Construction of 49.99MW Battery Energy Storage System With Associated Works

**Report by Head of Planning
& Economic Development**

SUMMARY OF REPORT

Figure 2 – Proposed Elevations

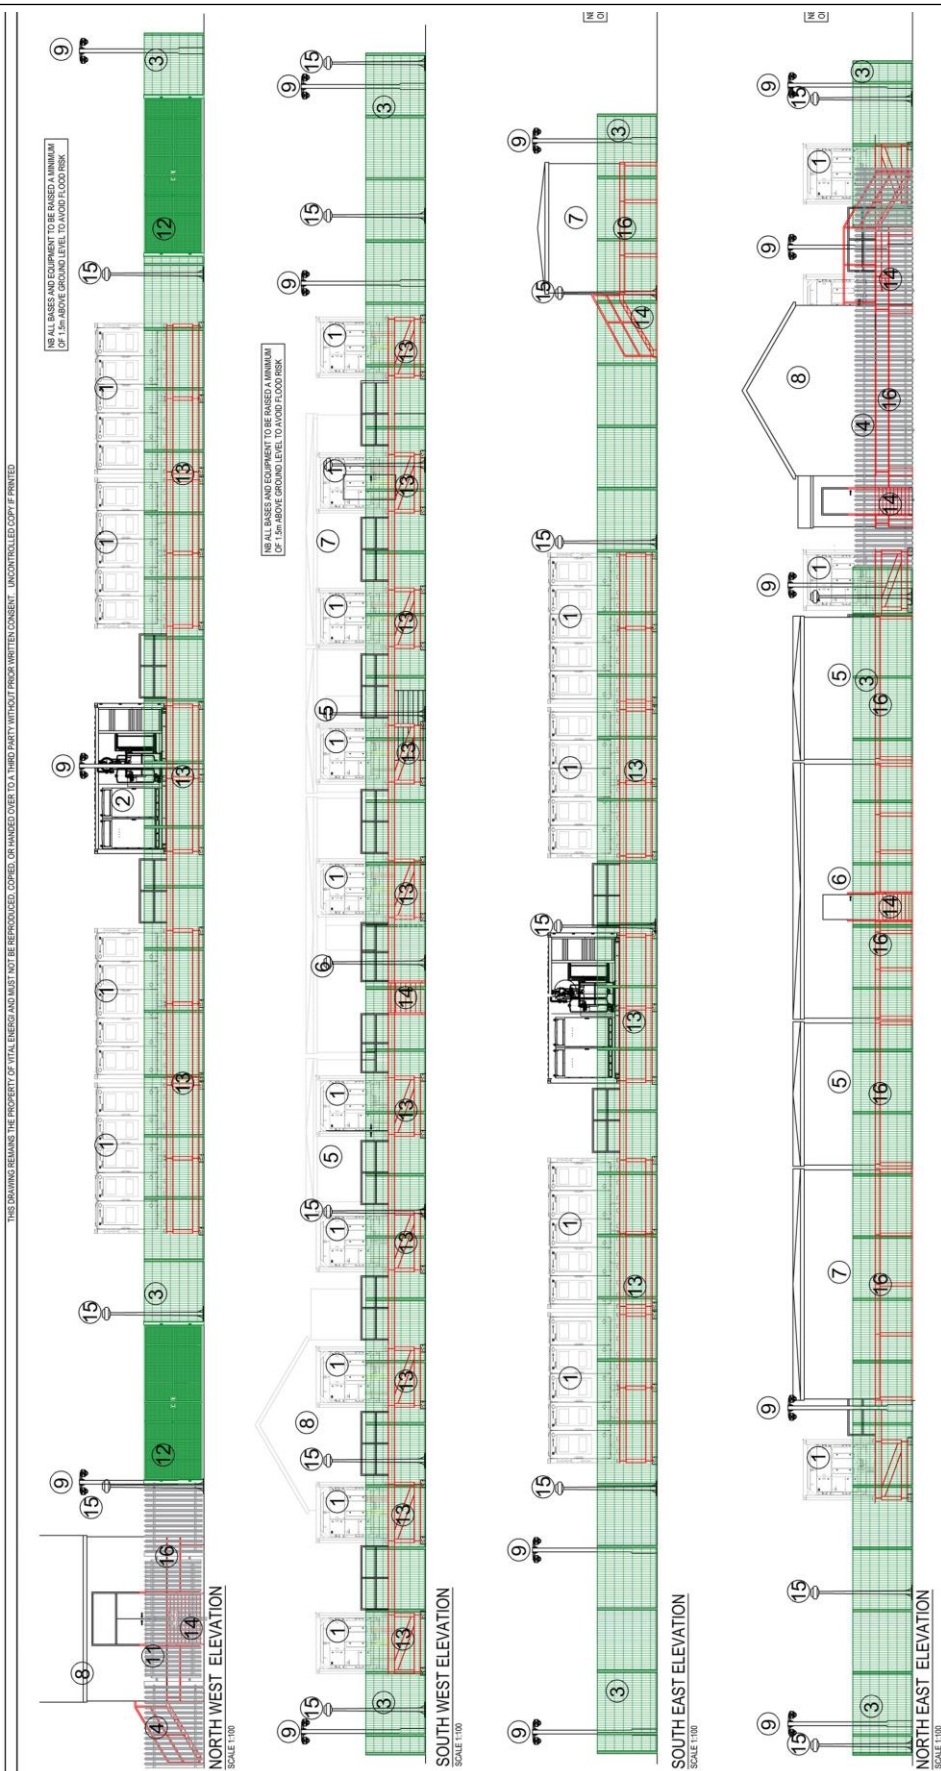
- 7.49 The proposal is for a battery energy storage system and associated infrastructure. The fenced compound which would contain the battery containers and associated infrastructure would measure 110 metres in length by 86 metres in width. A 5-metre-high acoustic fence with a total length of approximately 360 metres would be installed around the perimeter of the Battery Energy Storage System (BESS). The applicant advises that the final site design may be subject to change once final specifications are decided. This would include the exact locations, design, and materials of the battery units to allow for flexibility to incorporate the most efficient and up-to-date infrastructure available at the time of construction. If planning permission is approved, a condition will require submission of full details of the final locations, design and materials to be used for the battery units to be submitted to the planning authority for approval.

- 7.50 The design of the proposed BESS installations would be somewhat utilitarian in appearance with the proposed battery containers effectively having a similar size and profile to shipping containers.
